New Pressure Roller Design - RJ-900X

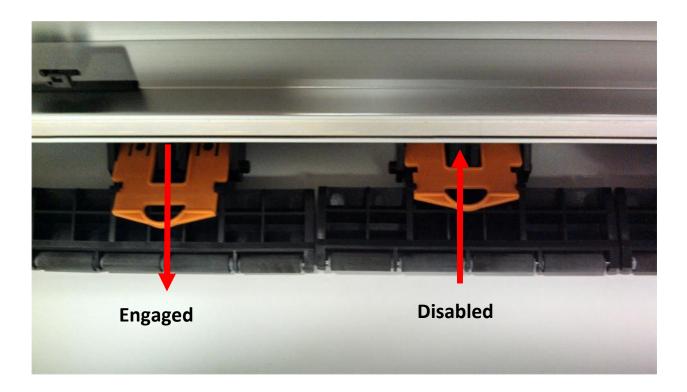
The newly re-designed RJ-900x has incorporated, among other improvements, an innovative new pressure roller system designed for printing on transfer papers for dye sublimation applications. This new design gives the operator the ability to individually disable the pressure rollers to allow the transfer paper to expand without cockling, greatly reducing the chance for head strikes and the need for extra media edge guides¹. This new roller cancellation function is very simple to use and fully customizable for different paper types and ink load requirements.

Each roller has an orange slide lock lever to either engage or cancel that roller. When the main pressure roller lever is in the UP position, you can slide the orange slide lock back to cancel each roller individually.

If the papers start to cockle causing head strikes, it is recommended to cancel/disable the first 2-4 rollers on both edges of the media, depending on media width. Keep as many rollers as needed engaged in the center of the media to ensure proper feeding.
